Addendum No.3
to
CONSTRUCTION DOCUMENTS
for

NCISD New District Administration Building
21330 Valley Ranch Parkway
New Caney, TX. 77357
June 2, 2025

Below is a summary of the sheet and specification revisions for Addendum #3.

MECHANICAL ENLARGED PLANS

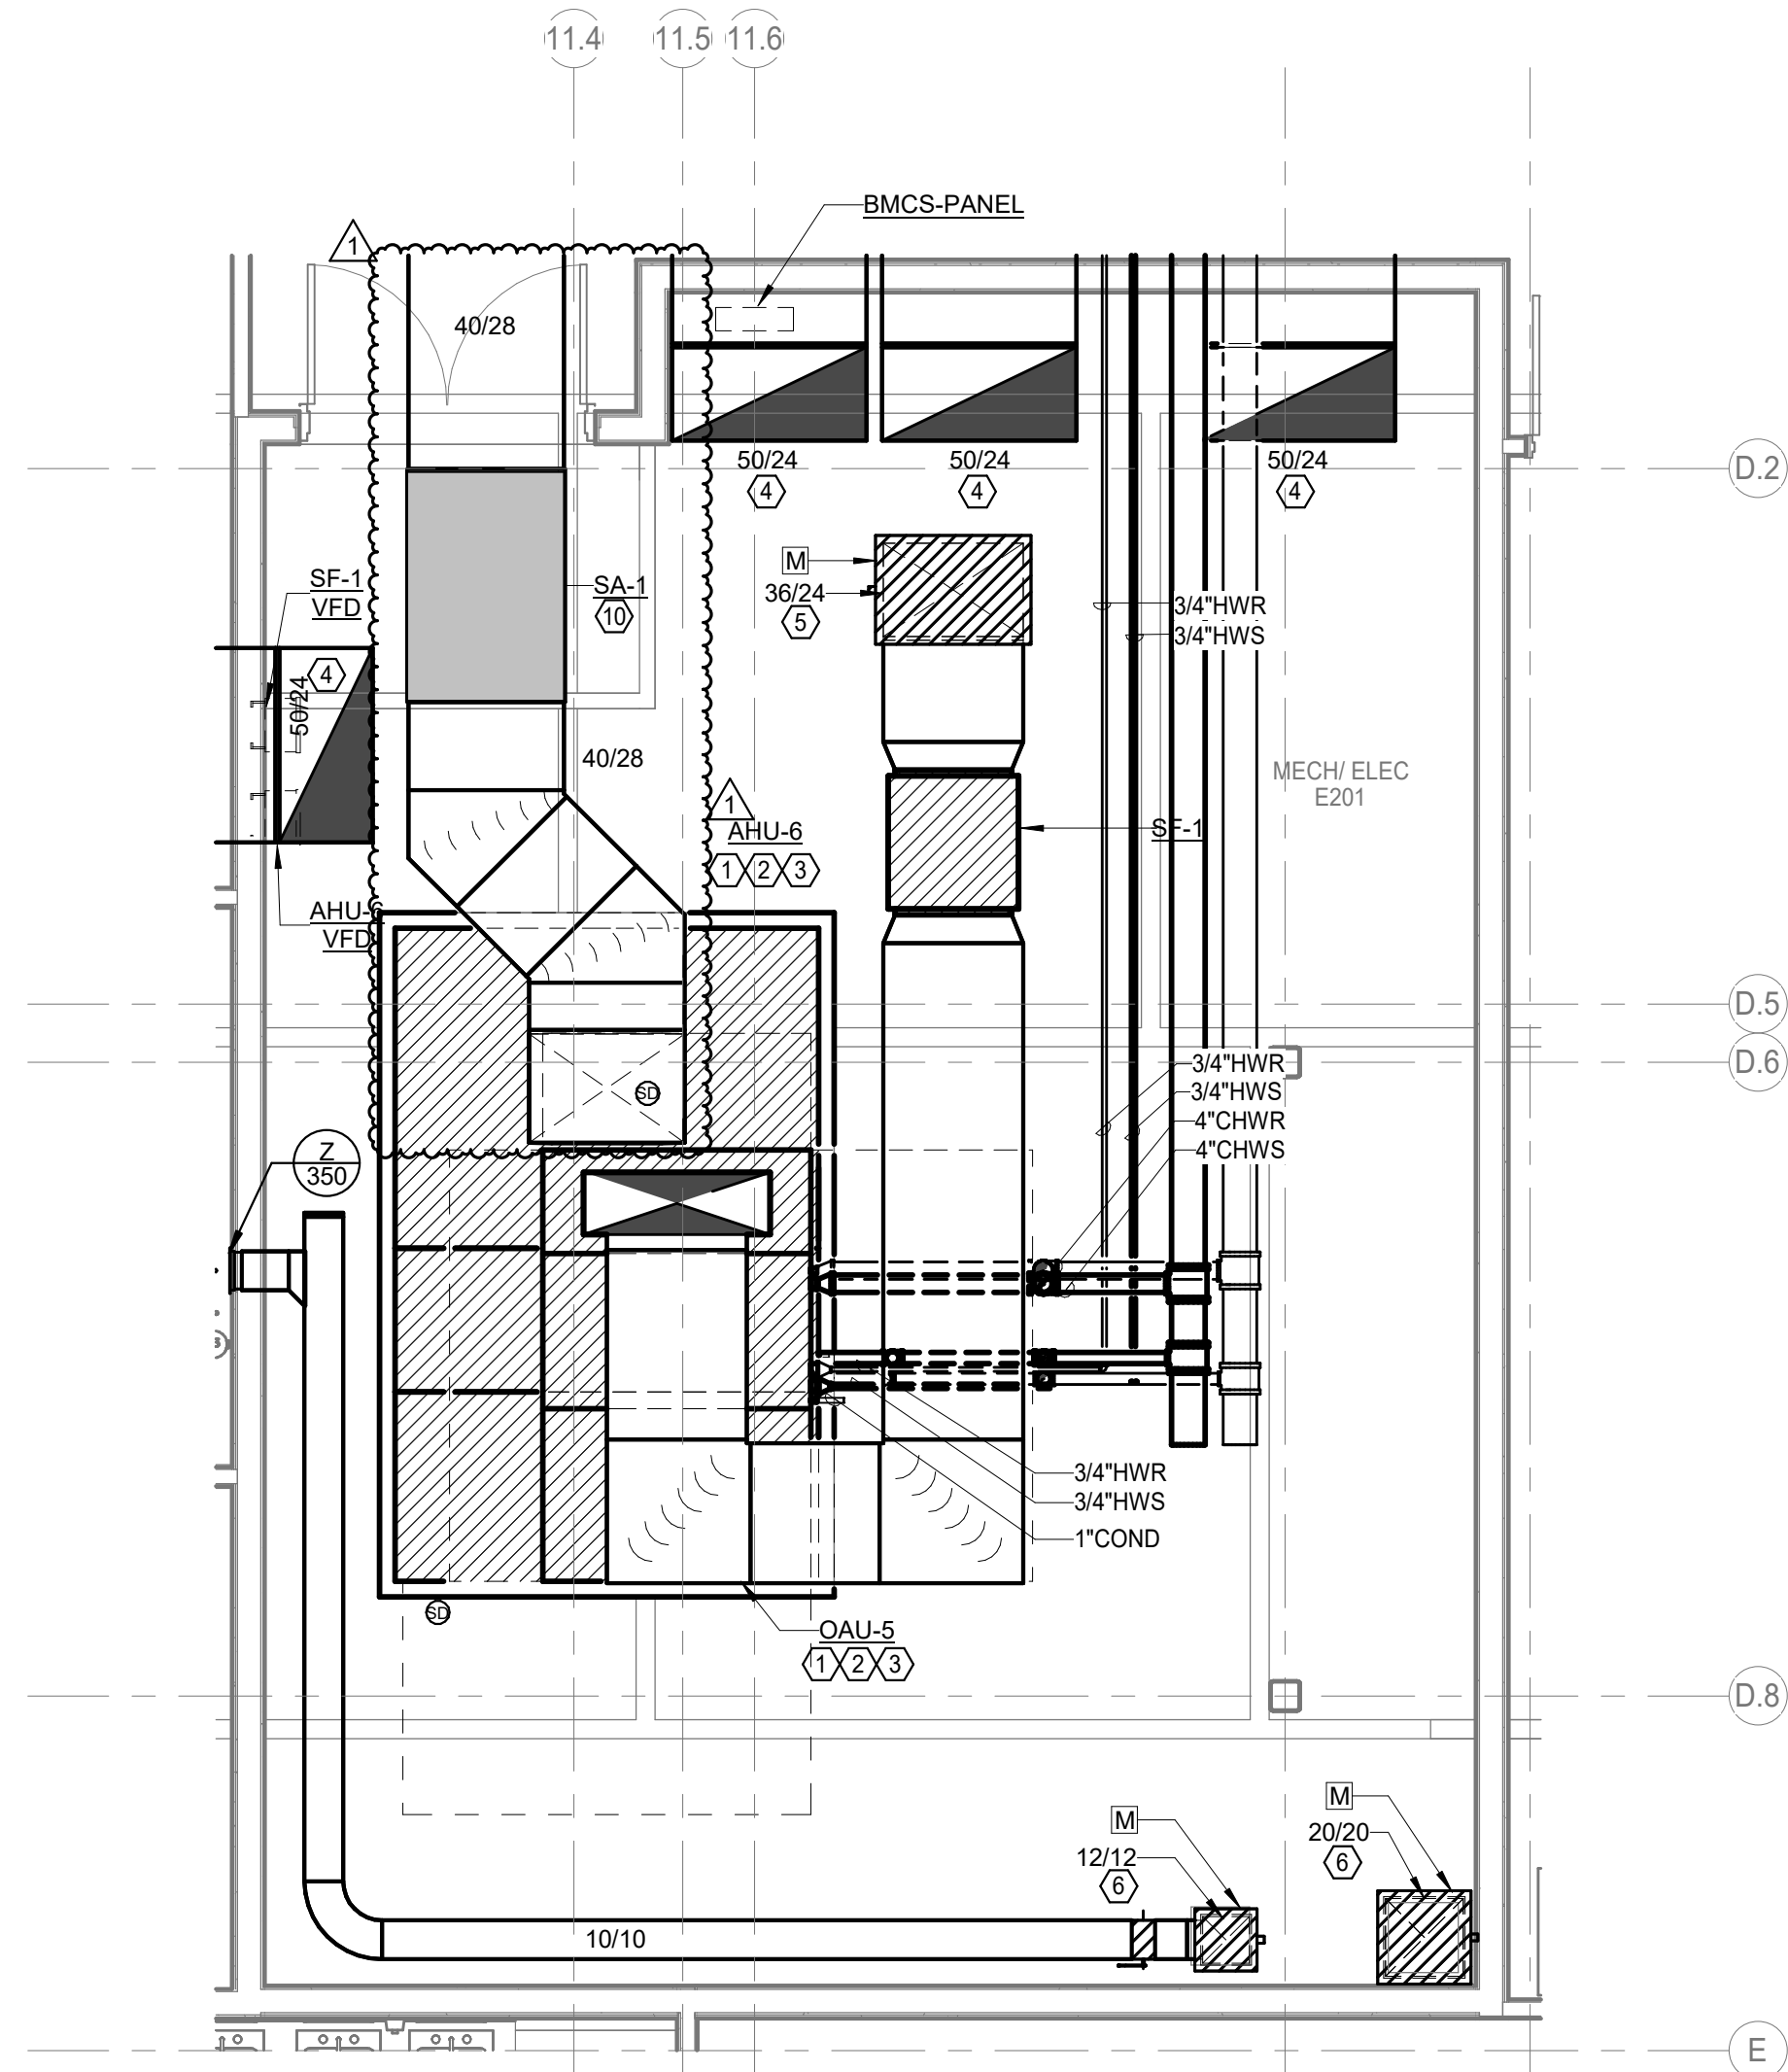
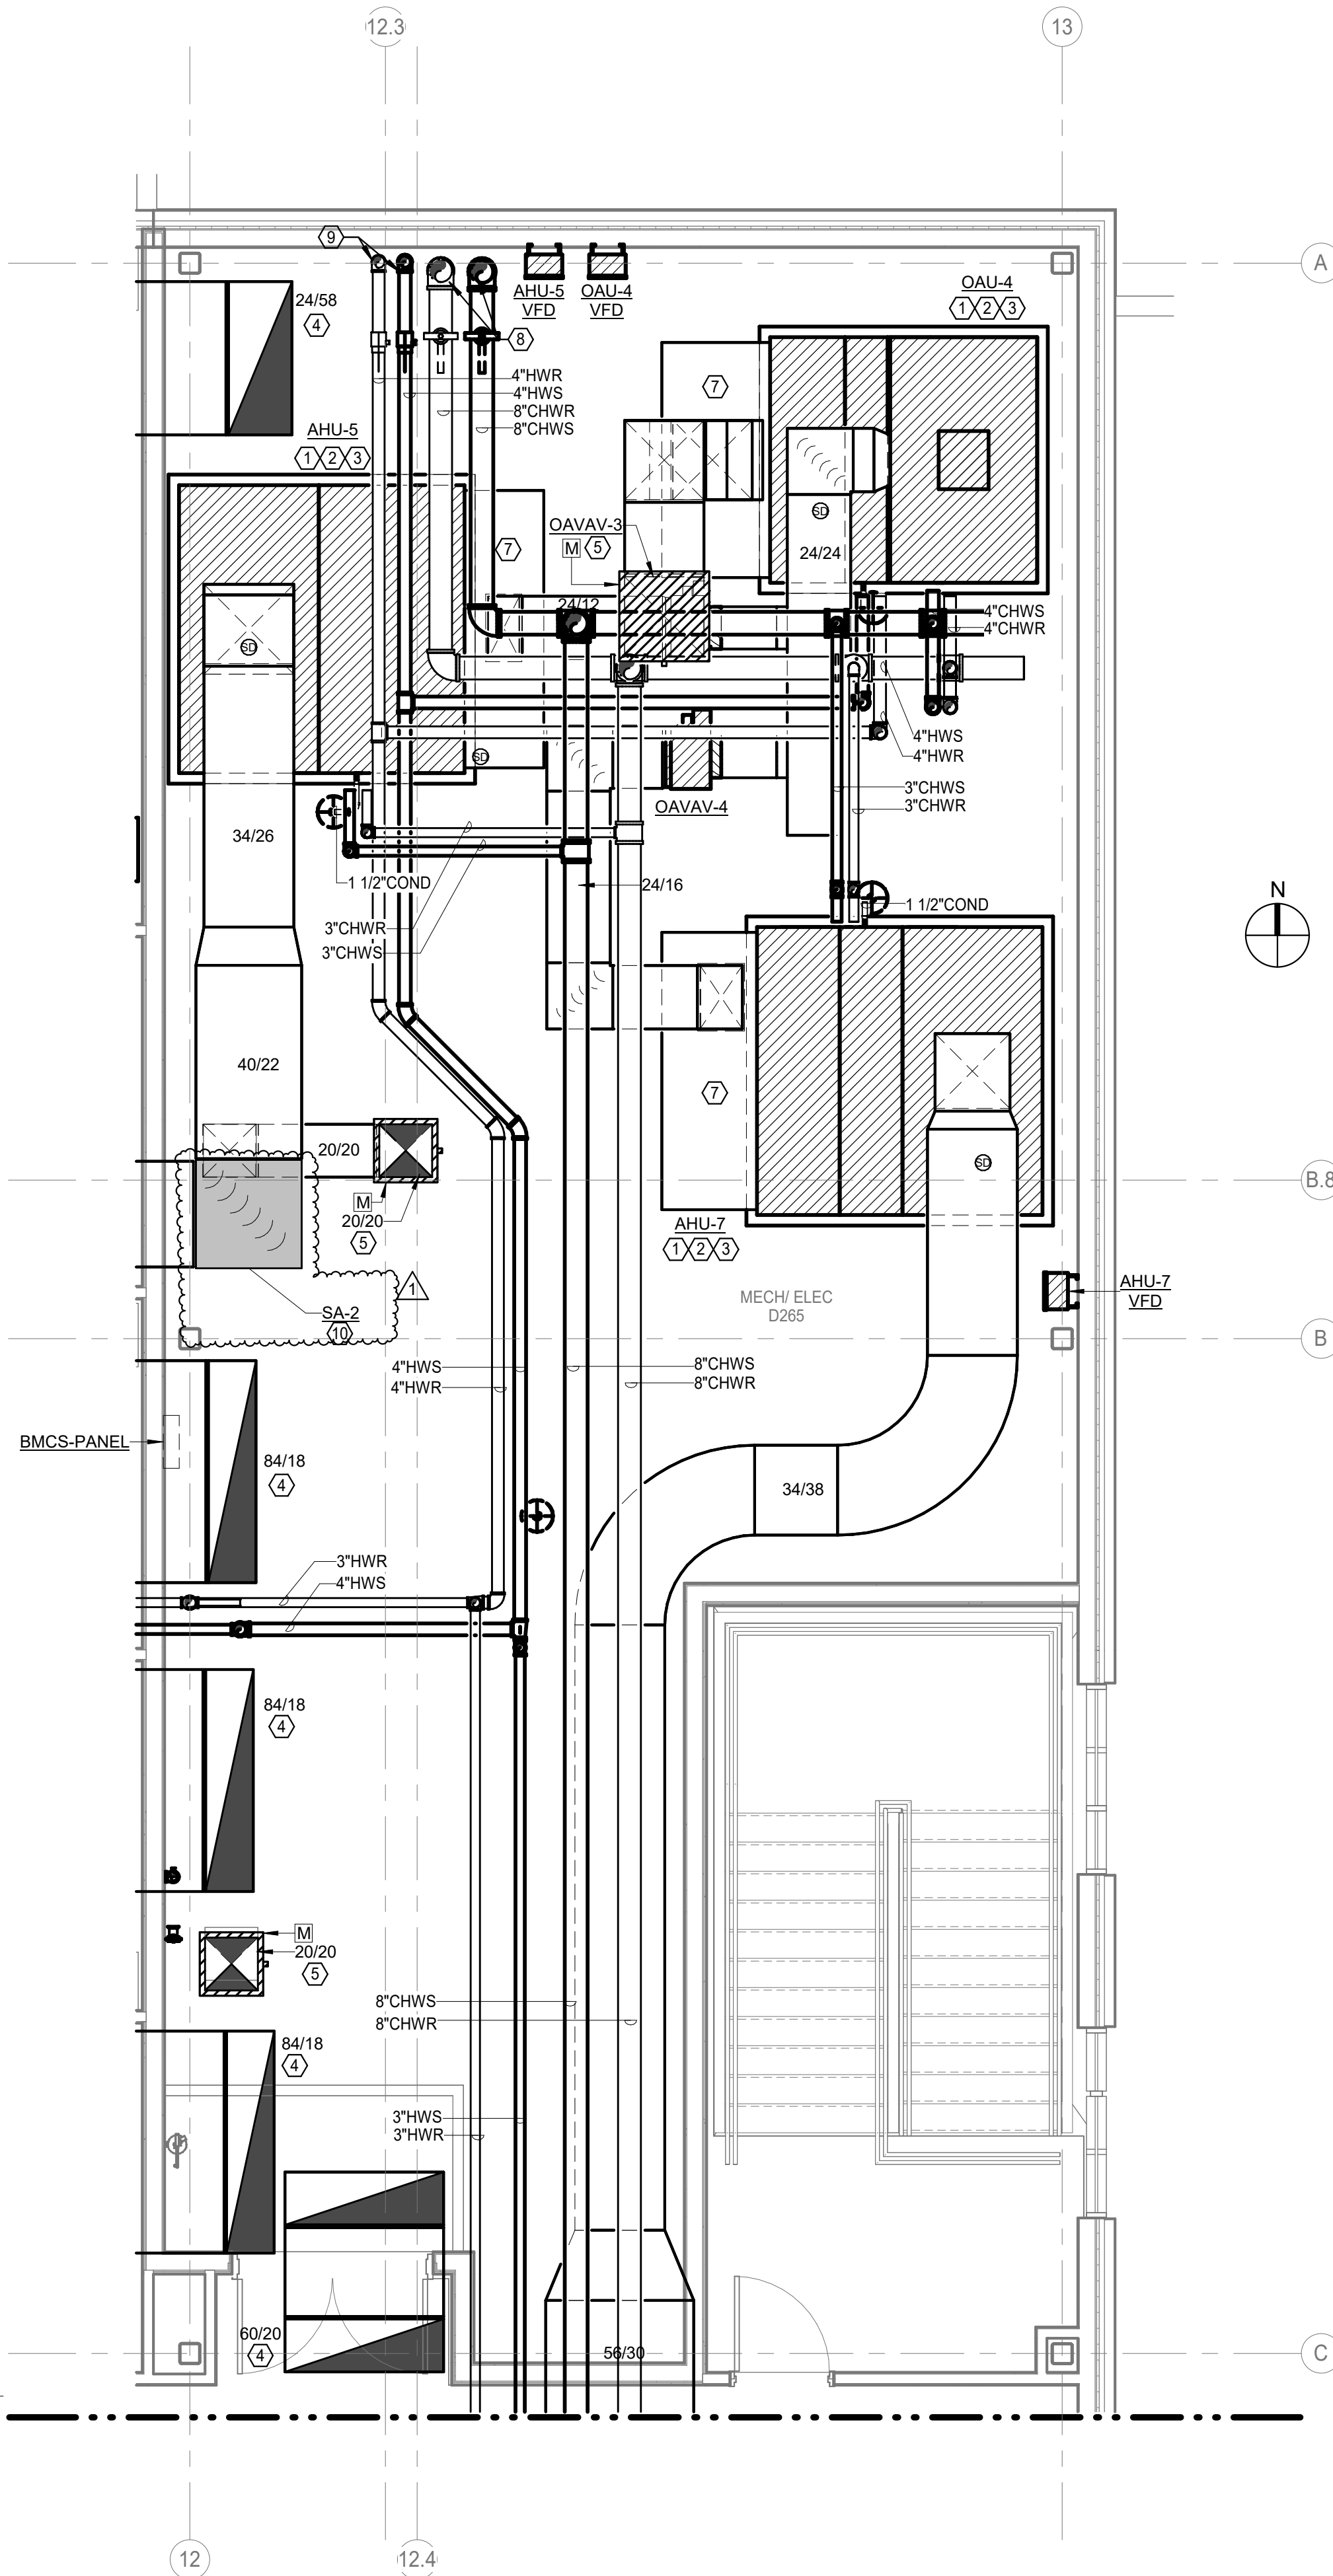
7. SHEET M-118 – MECHANICAL ROOF PLAN
 - a. Revise location of EF-10 to reflect updates from sheet M116-F2. Refer to sheet.
8. SHEET M-202 – MECHANICAL SECOND FLOOR AREA – F2

- a. View #3: Add elbow sound attenuator in ductwork served by AHU-5.
 - b. View #4: Add sound attenuator in ductwork served by AHU-6.
9. SHEET M-501 – MECHANICAL SCHEDULES
